Approved Section 4.55 (.....2.....) Modification Application

Project
BARANGAROO STAGE 1B
PUBLIC DOMAIN
Modification S4.55

Drawing Title
WATERMANS QUAY
DETAIL PLAN - TREES

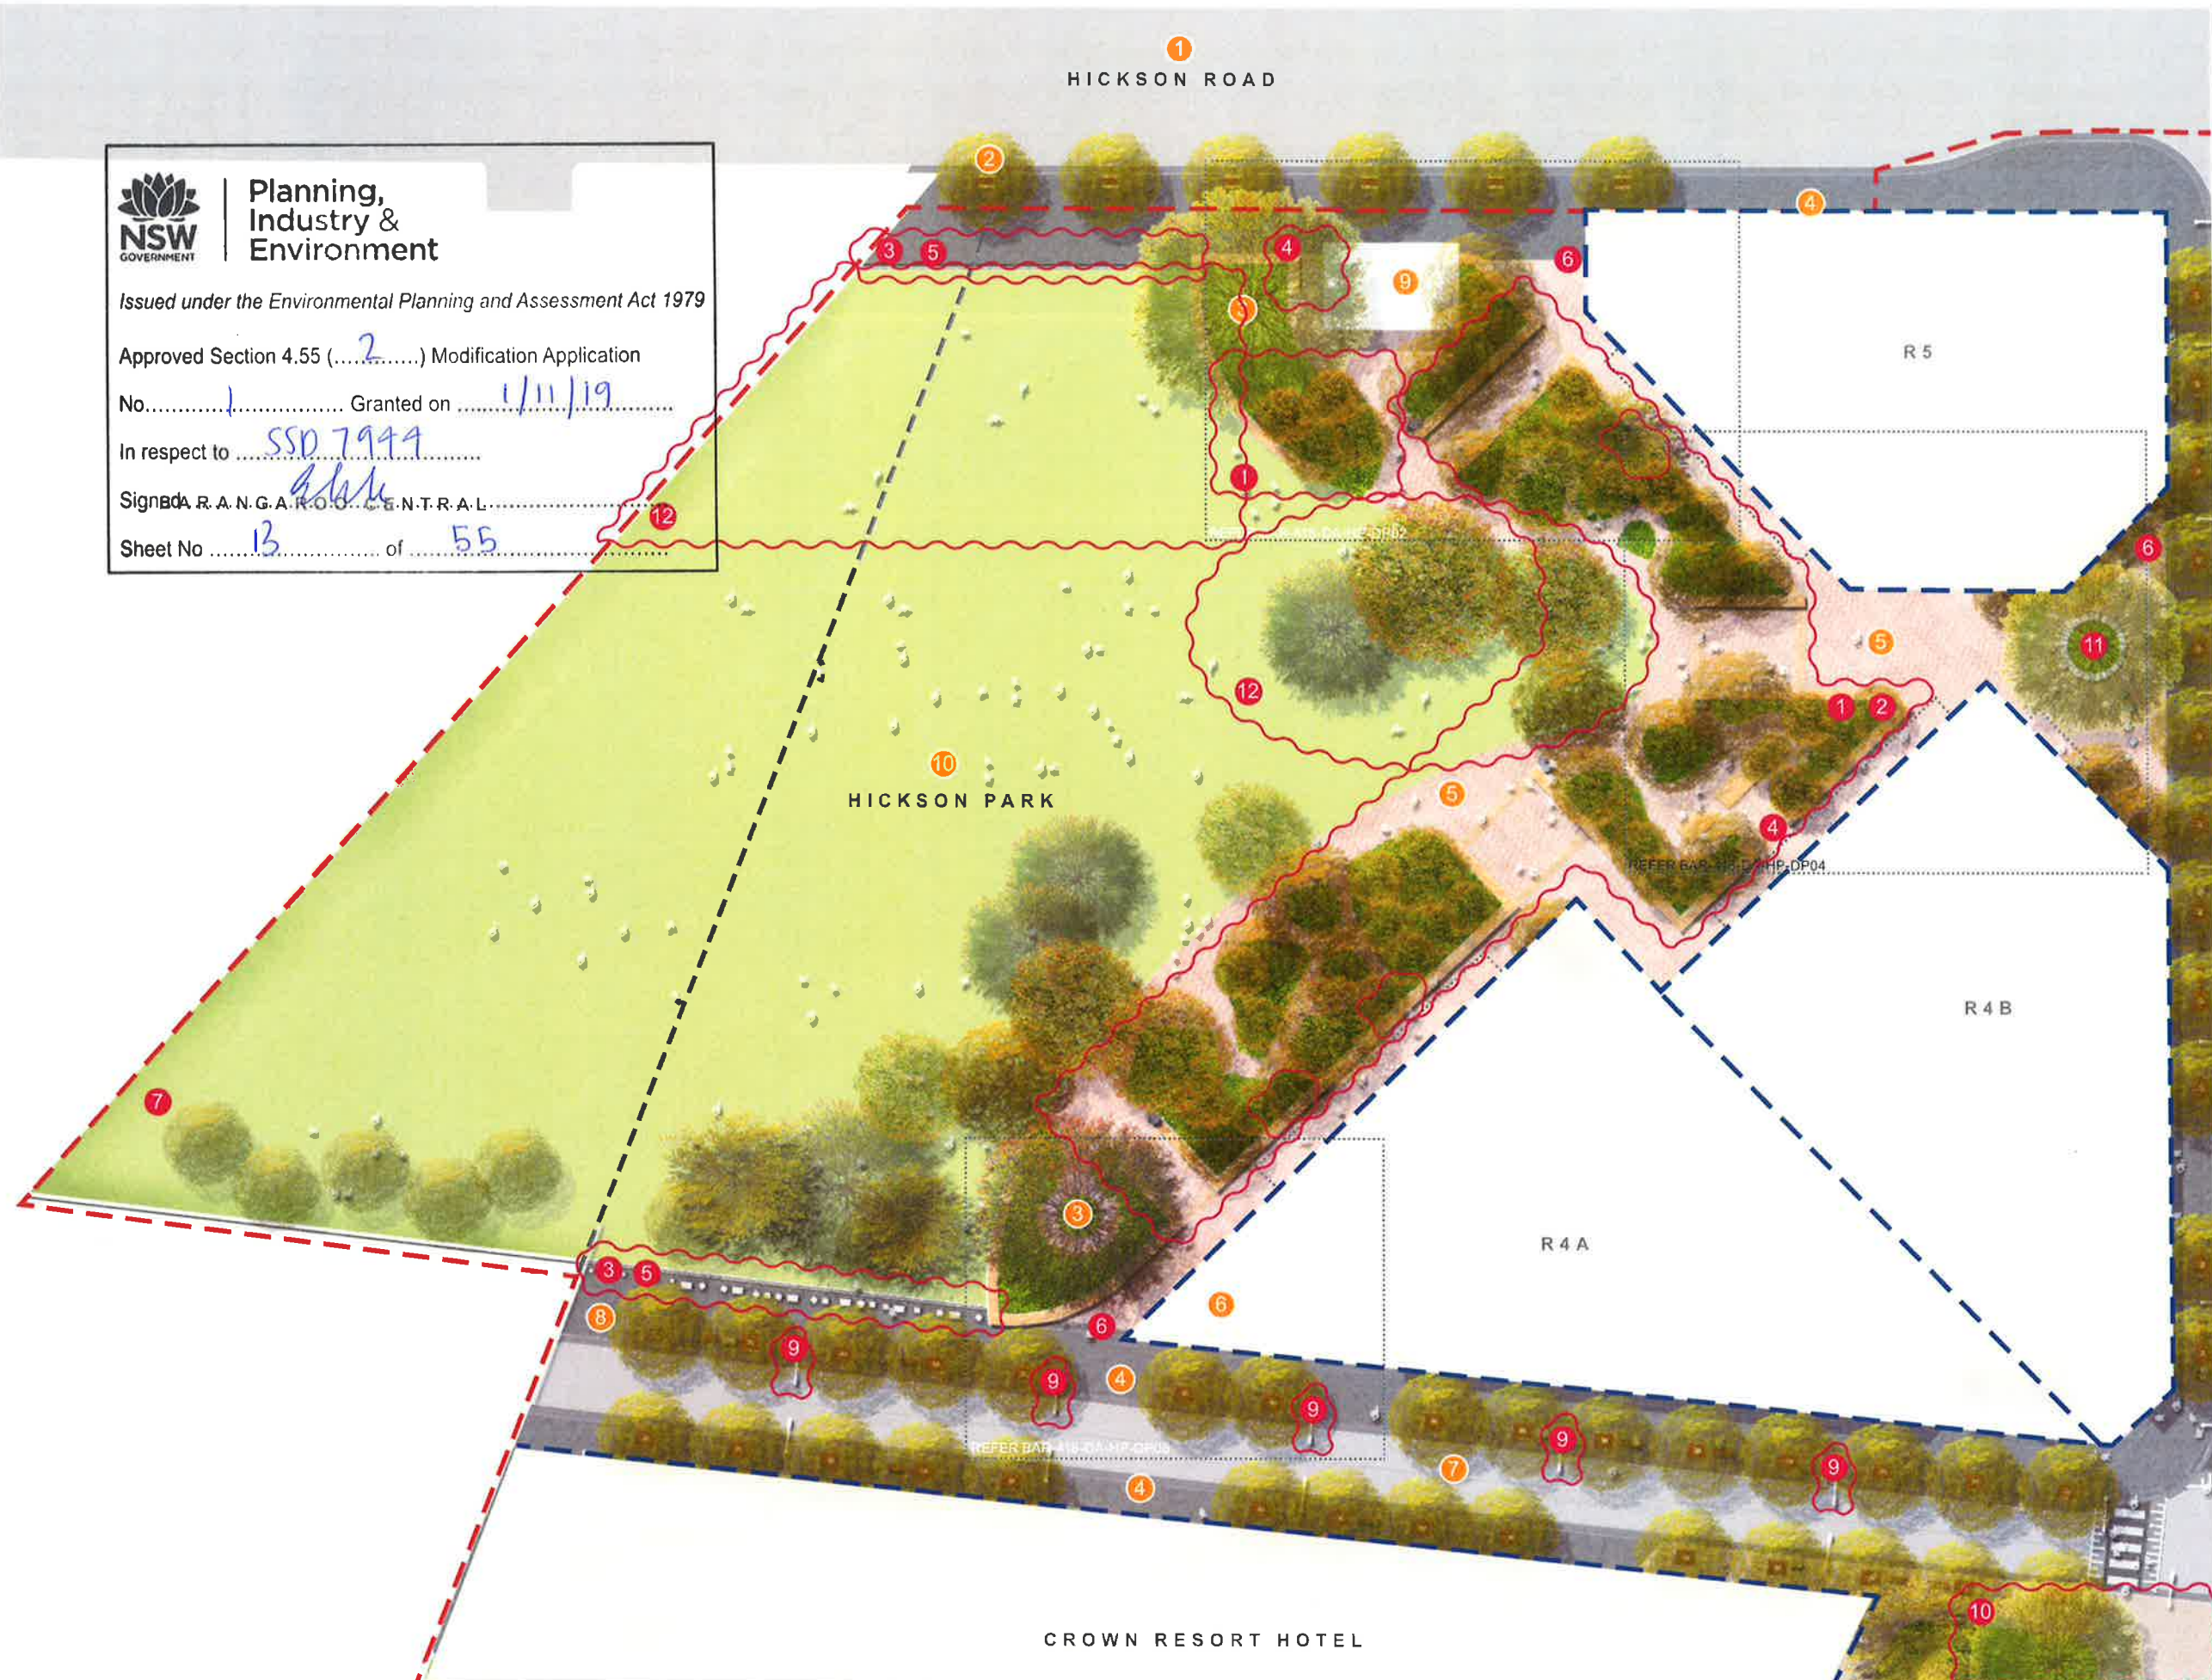
- Amendment cloud
- 1 Increase planting area within the park, change of geometry and remove 3no. access stairs.
- 2 Shift ramps to align to buildings
- 3 Sandstone paving strip changed to City of Sydney paving along Hickson Park
- 4 Stone stairs changed to concrete
- 5 Sandstone bollards changed to concrete, setout amended & delete bollards to East par edge.
- 6 Remove porphyry paving to City of Sydney transition as per consent requirement B23
- 7 Additional temporary tree as per consent requirement B29. Subject to Secretary's approval.
- 8 Not in use
- 9 Additional smart pole
- 10 Relocated Fig tree to North raised planter
- 11 Remove timber top for Watermans Quay raised planter seating
- 12 Levels changed due to Hickson road levels change

Drawing Title
**HICKSON PARK
MASTERPLAN - NO TREES**

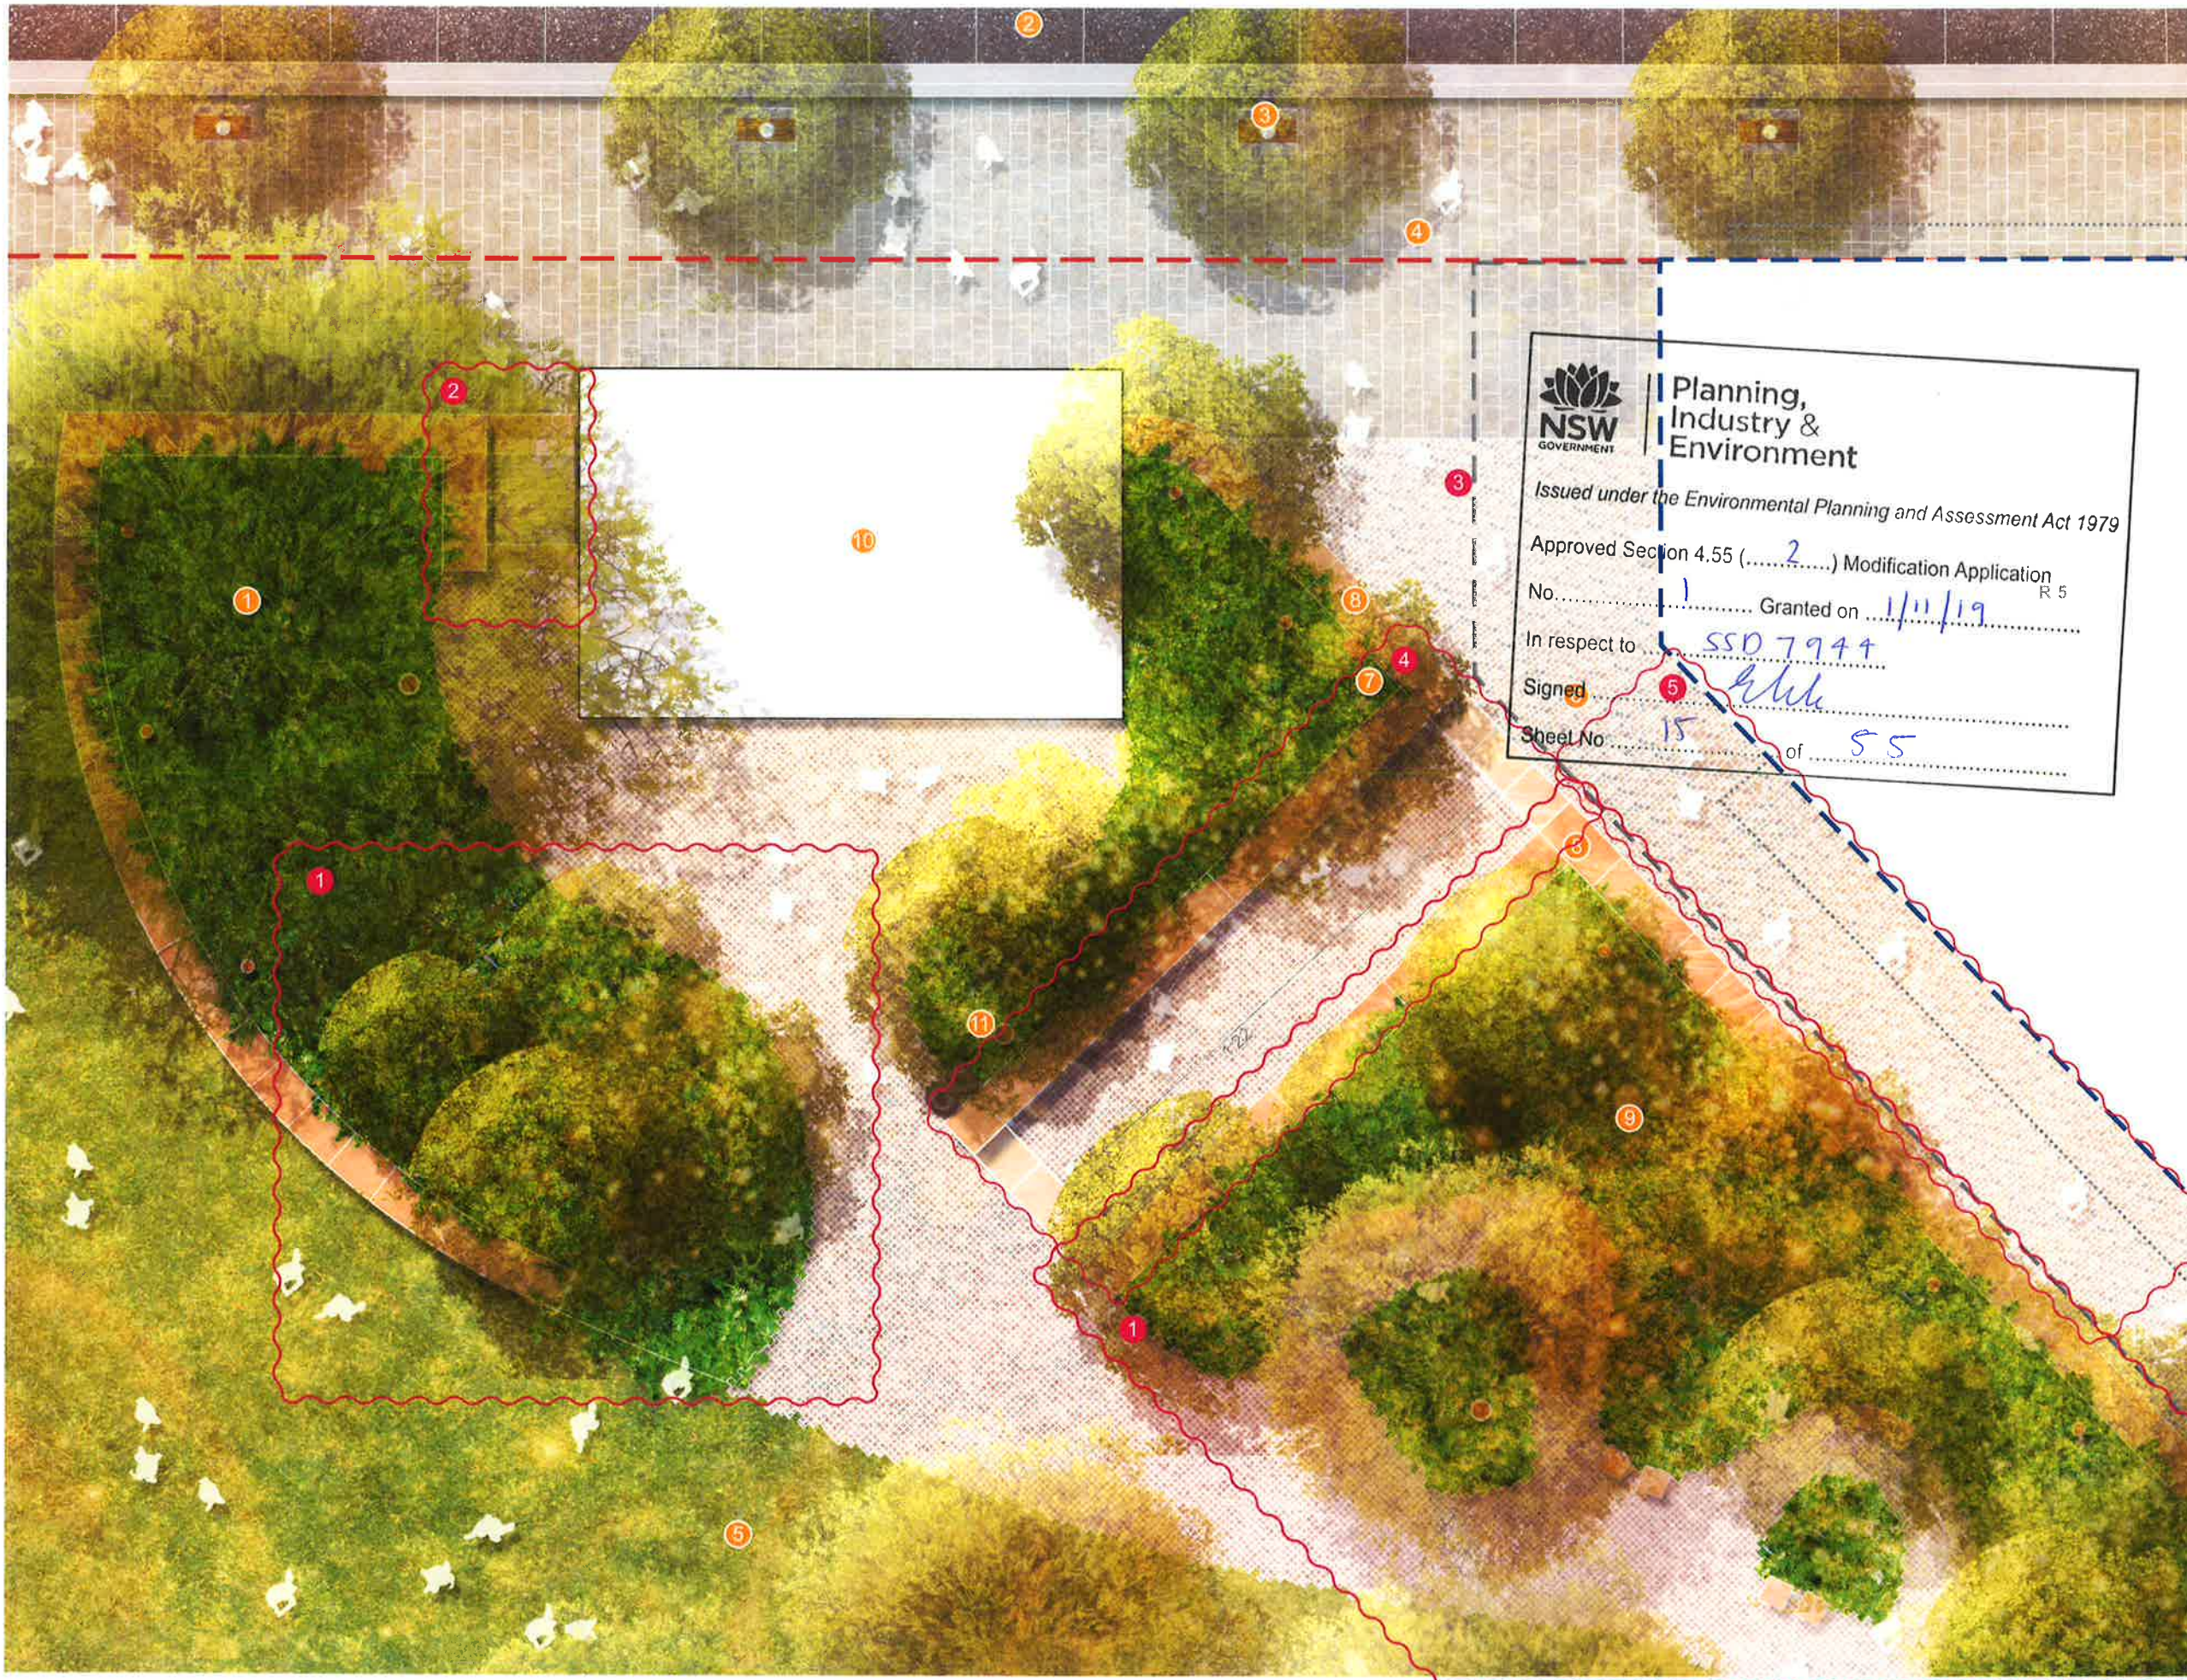
- 1 Increase planting area within the park, change of geometry and remove 3no. access stairs.
- 2 Shift ramps to align to buildings
- 3 Sandstone paving strip changed to City of Sydney paving along Hickson Park
- 4 Stone stairs changed to concrete
- 5 Sandstone bollards changed to concrete, setout amended & delete bollards to East parking edge.
- 6 Remove porphyry paving to City of Sydney transition as per consent requirement B23
- 7 Additional temporary tree as per consent requirement B29. Subject to Secretary's approval.
- 8 Not in use
- 9 Additional smart pole
- 10 Relocated Fig tree to North raised planter
- 11 Remove timber top for Watermans Quay raised planter seating
- 12 Levels changed due to Hickson road levels change
